VERNE MILNE MOTORS, REPOROA

EXTENSION TO WORKSHOP WITH SERVICING PIT

LAYOUT &
STRUCTURAL DETAILS

DWG. No. 69-20-02

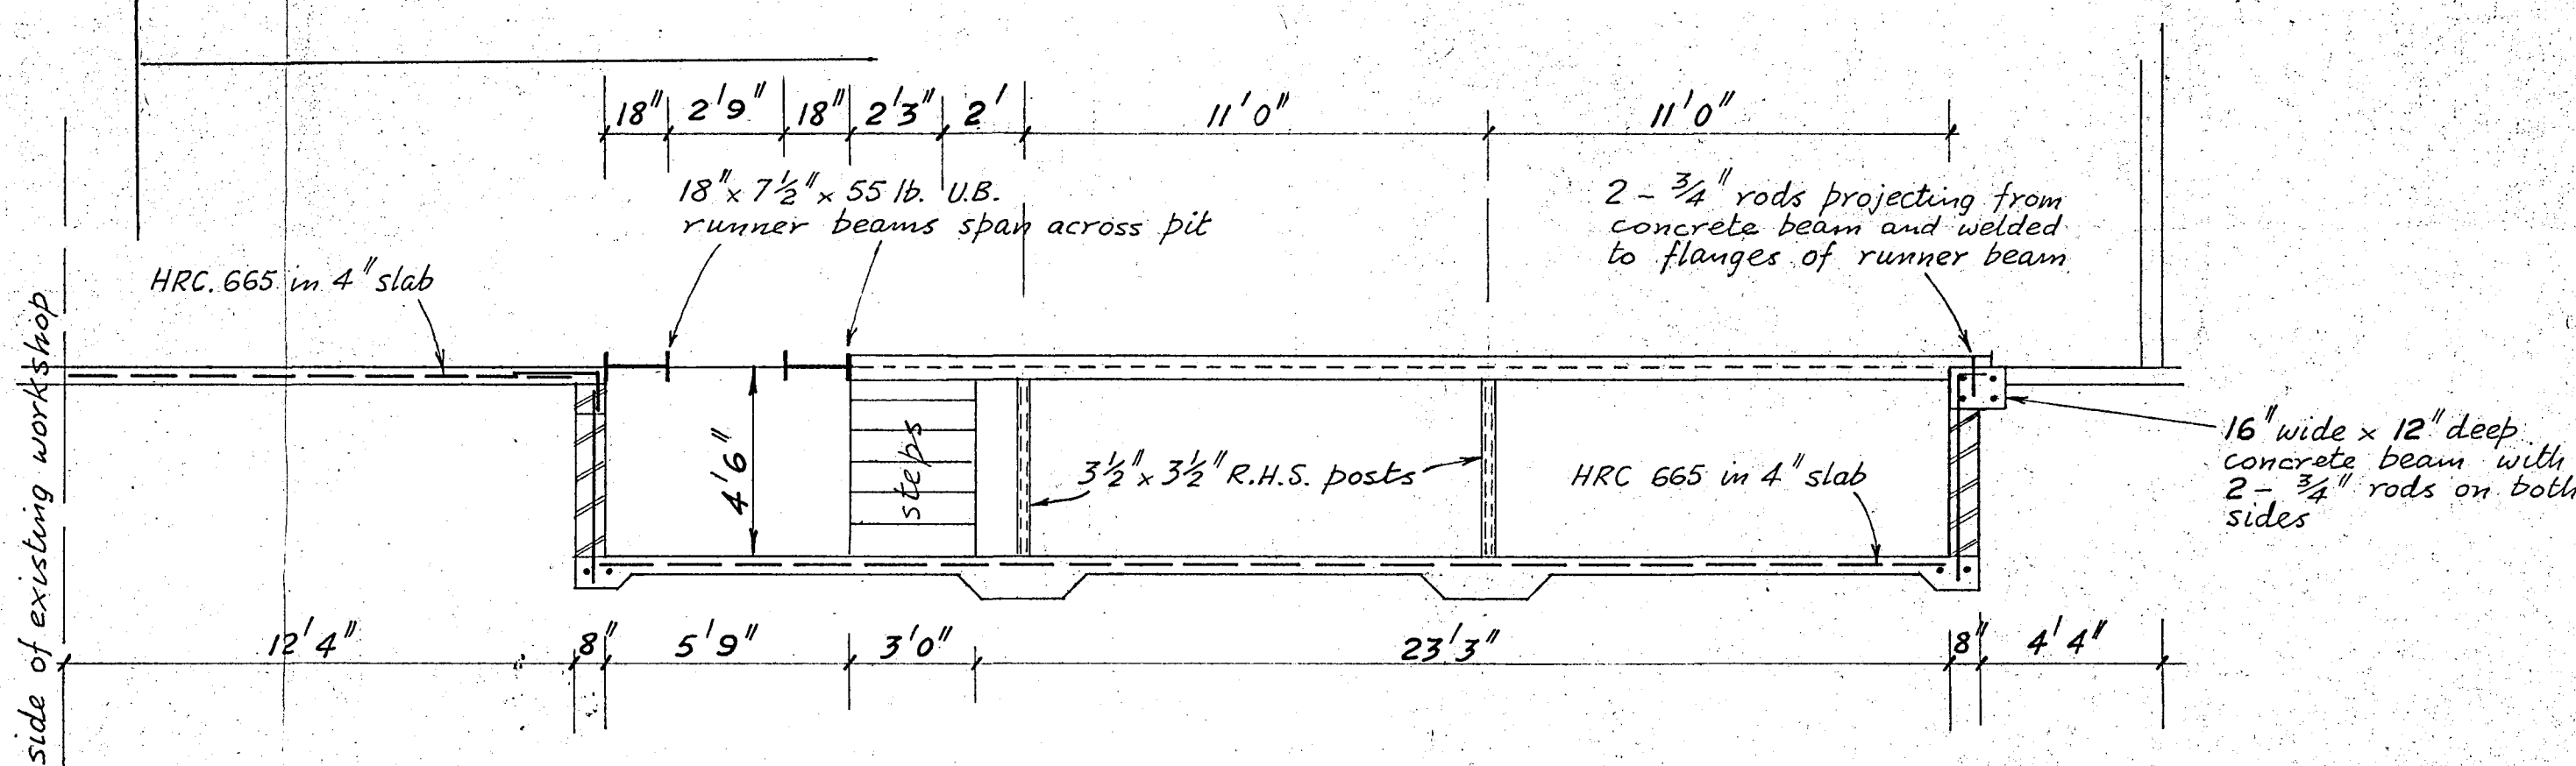
In place of 10x2 rafters (because not being practical with knee braces.)
Prefab 4x2 hollow section steel trusses @ 10' spacing + 6x2 purlins.
